HL-5286

Edwin I. Hatch Nuclear Plant  
Third 10-Year Interval Inservice Inspection Program  
Request for Relief

**GEORGIA POWER COMPANY  
HATCH NUCLEAR PLANT, UNITS 1 & 2  
THIRD 10-YEAR INTERVAL  
REQUEST FOR RELIEF NO. RR-18**

HATCH UNIT 1-RPV STABILIZER BRACKET

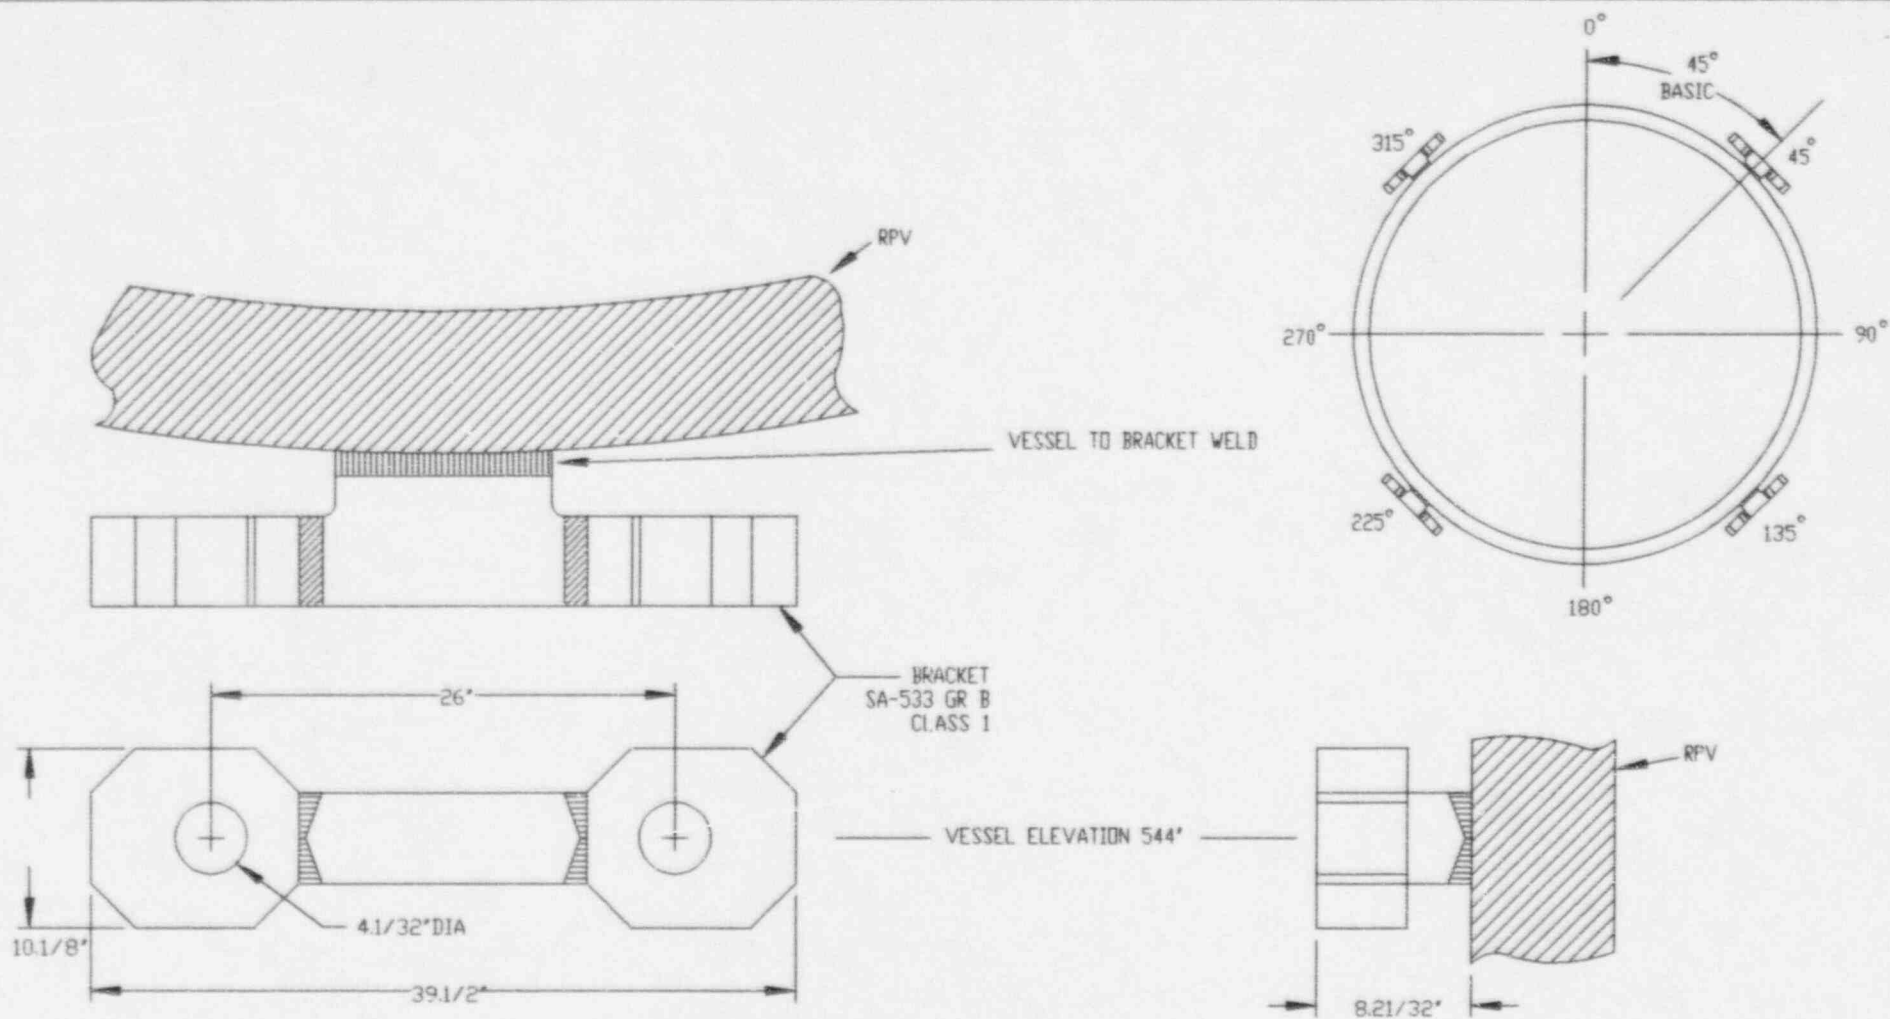
Hatch Unit 1 has a "Tee" shaped bracket stabilizer bracket welded to the RPV as shown in Figure 1. This design prevents examination of the weld located on the ends of the bracket between the "ears" of the tee and the RPV wall. Additionally, the bottom of the bracket cannot be examined due to the limited distance between the bracket and the shield wall. With such a small opening, especially considering the additional interference from other components of the stabilizer assembly and vessel insulation, insufficient space exists to perform the required examinations. Approximately 30 to 35% of the weld can be examined on each Unit 1 bracket.

HATCH UNIT 2-RPV STABILIZER BRACKET

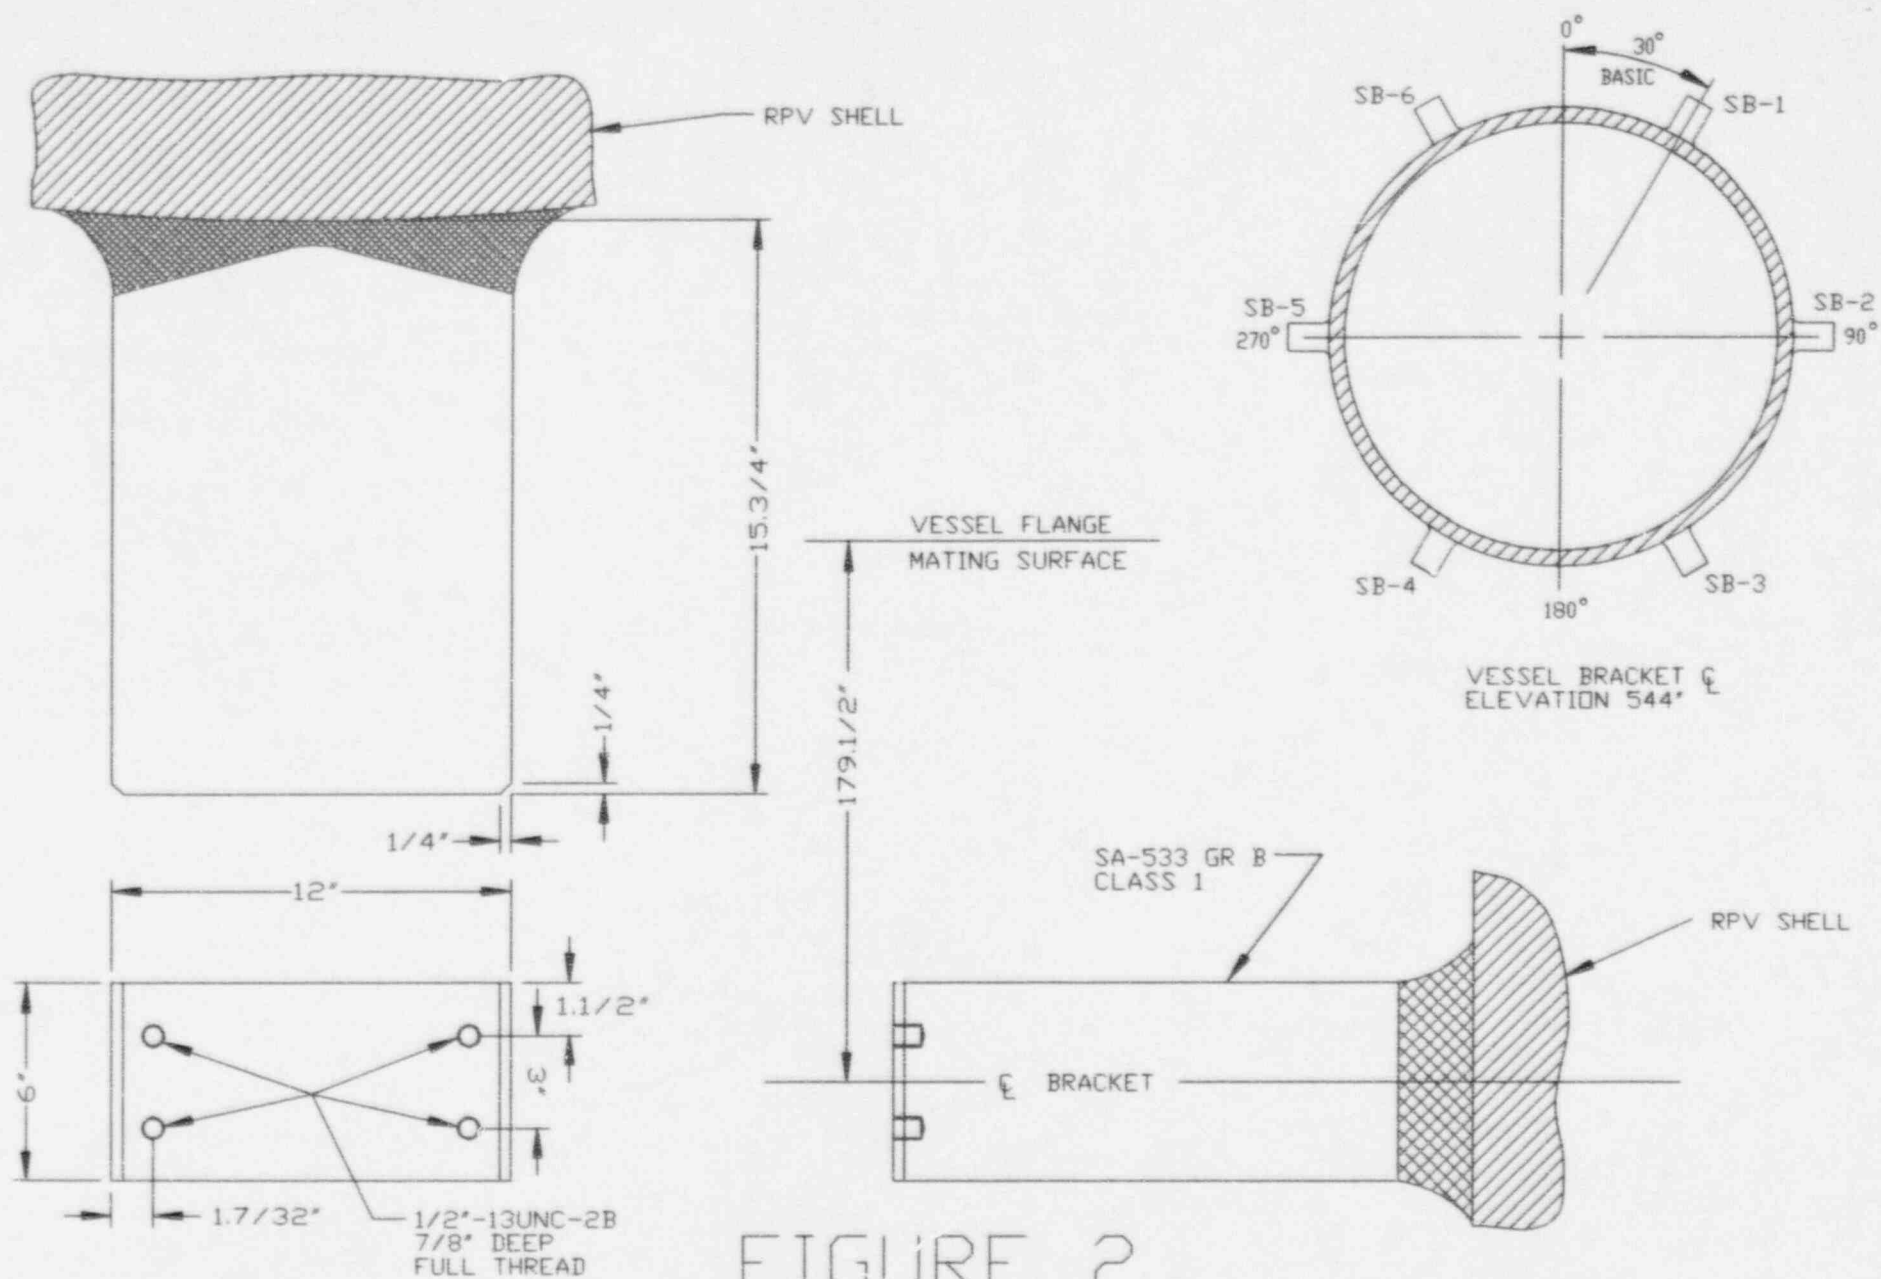
Hatch Unit 2 has a more conventional "lug type" design, as shown in Figure 2, that extends approximately 15" from the RPV surface. With this extension and the above described interference, the bottom portion of the weld cannot be accessed for examination. The top of the weld and both sides of the weld can be examined, resulting in a coverage of approximately 65 to 70%.

HATCH UNIT 1 AND 2-RPV TOP HEAD WELD DETAIL

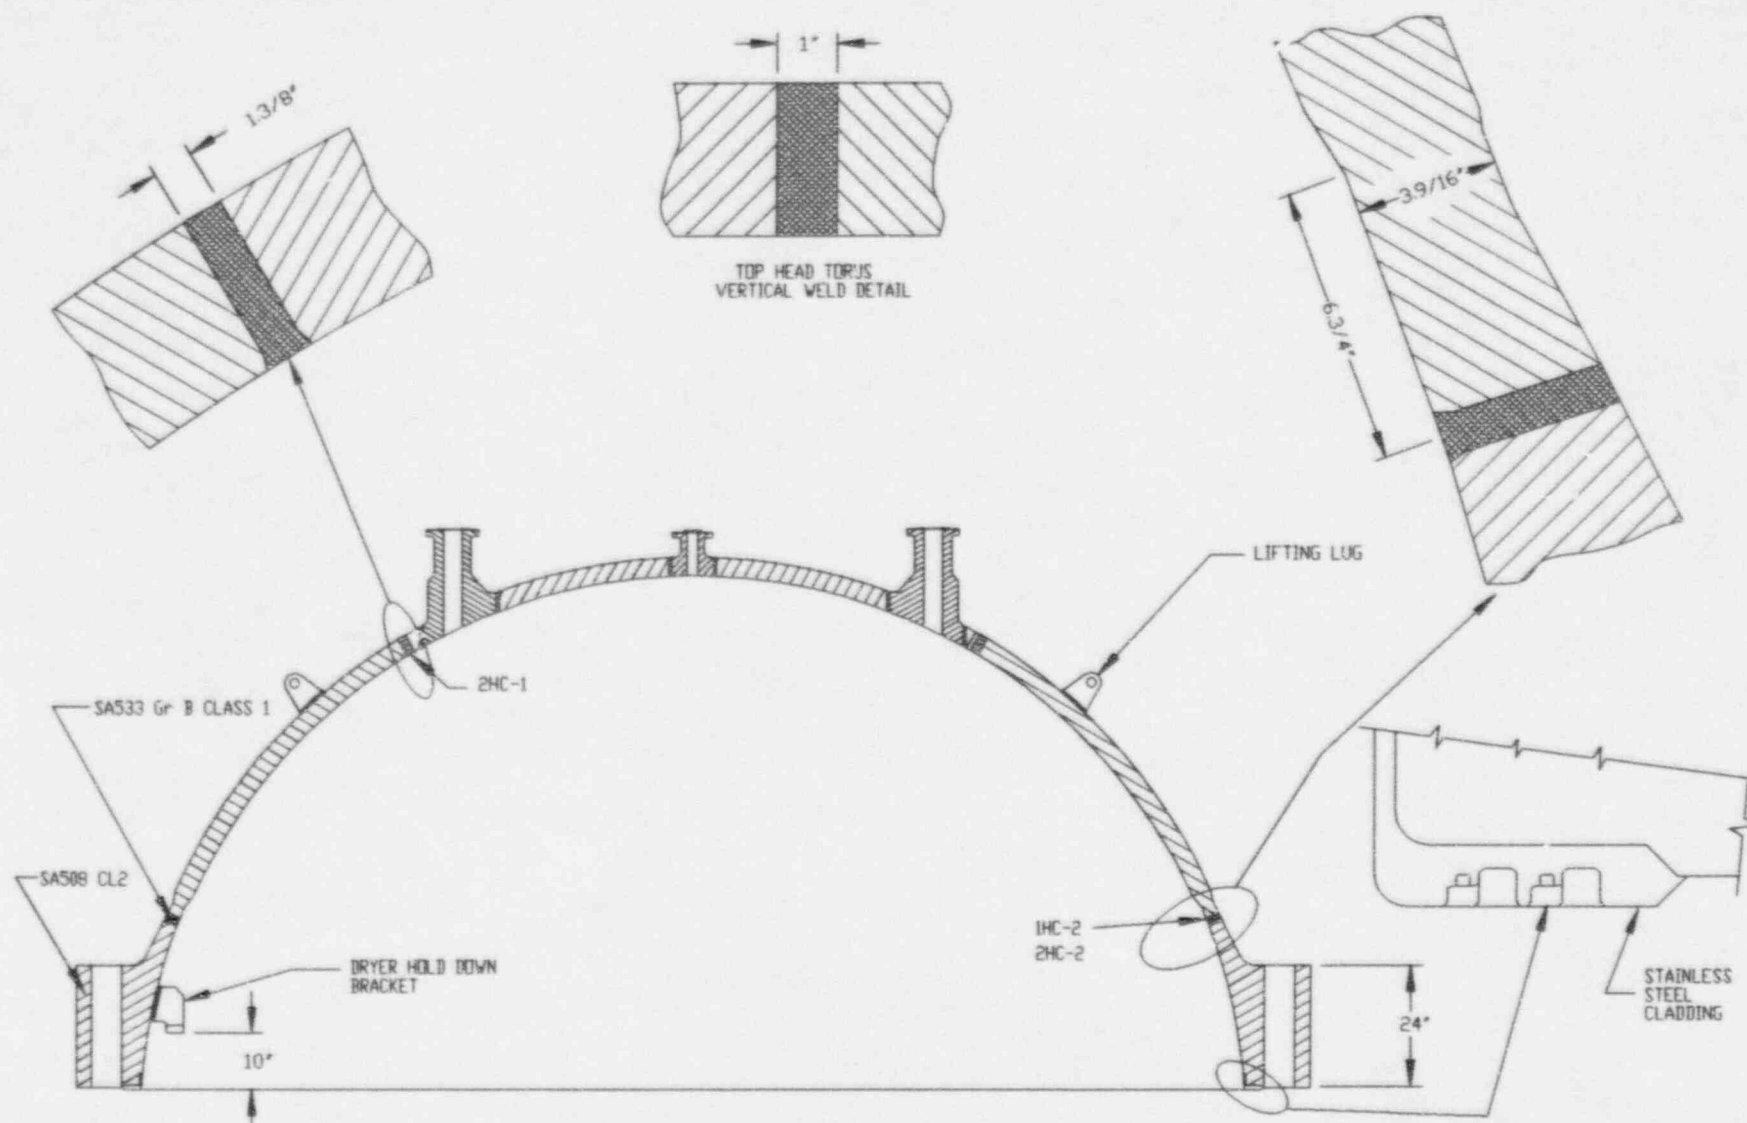
- III. Code Requirement for Which Relief is Requested: Limitations exist that preclude complete volumetric examination of the head-to-flange welds.
- IV. Basis for Relief: As shown in Figure 1, head-to-flange welds 1HC-2 and 2HC-2 are located such that ultrasonic scanning can be performed for about six inches on either side of the respective weld. Past the six inches, on the dome side, there is a taper that joins two different thicknesses together, while on the flange side there is a strong curvature. Outside the six-inch scanning area, on each side of these welds, meaningful examination is not possible due to the configuration.

With the existing accessibility, the 0-degree scan can be performed over the entire examination volume. Using a 45-degree scan, approximately 85% of the examination volume can be scanned from both sides of the weld with all of the volume scanned from at least one direction. The 60-degree scan has more significant limitations since a longer distance from the weld centerline is needed to perform the scan. Approximately 25% of the examination volume cannot be scanned from either direction with the 60-degree scan.
- V. Alternate Examination: None.
